**SERVICE BULLETIN**

**NUMBER:** 12-299-20R  
**DATE:** 09/04/2020  
**REVISED:** 08/15/2023

**SUBJECT:** 6/8-way and Driver's Seat Hinge Cover-  
 Design Change

Enlarged View of Damaged Claw

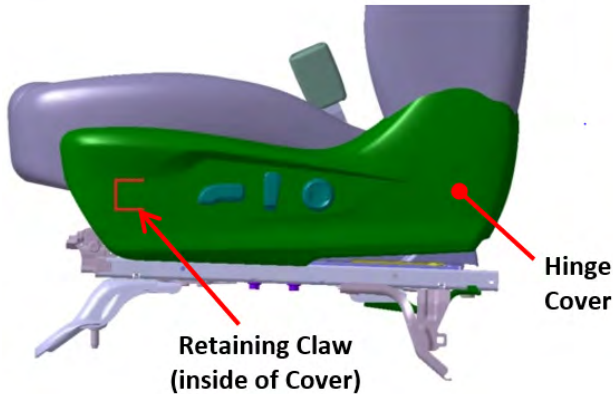
This bulletin announces a design change made to the outer hinge cover on the driver's 10-way adjustable power seats. The change has been made to address several reports about the cover coming loose over time as a result of getting into and out of the driver's seat. The retaining claw portion securing the cover to the seat frame has been changed to improve its strength and durability.
